TECHNICAL SERVICE BULLETIN

Subject: TSB for New Laptop Interface pigtail (690210)

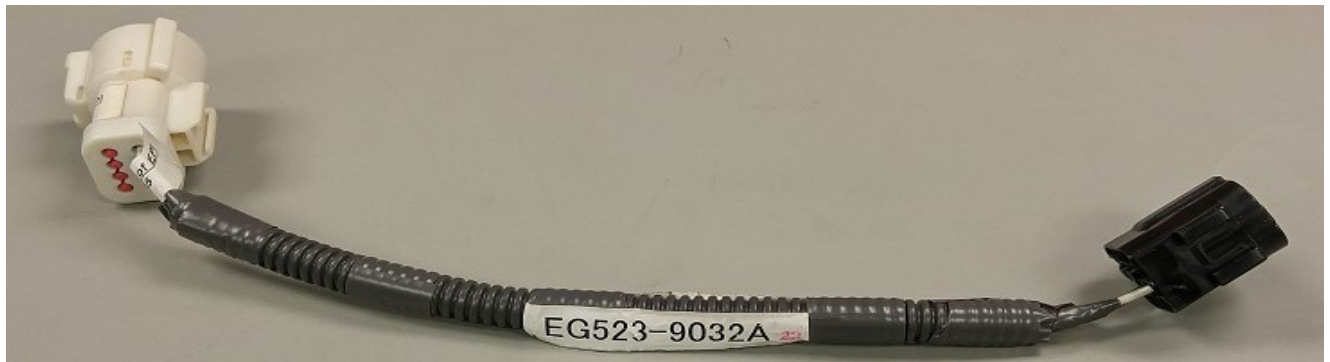
The diagnostics connector on the engine has changed due to an update in the engine wire harness from Kubota and will need the new pigtail **WITH** the standard interface cable to connect to engine for diagnostics troubleshooting.

Needed to connect to engine diagnostic connector. If you have ordered the standard interface cable from PBoss please get in contact with us regarding this update.
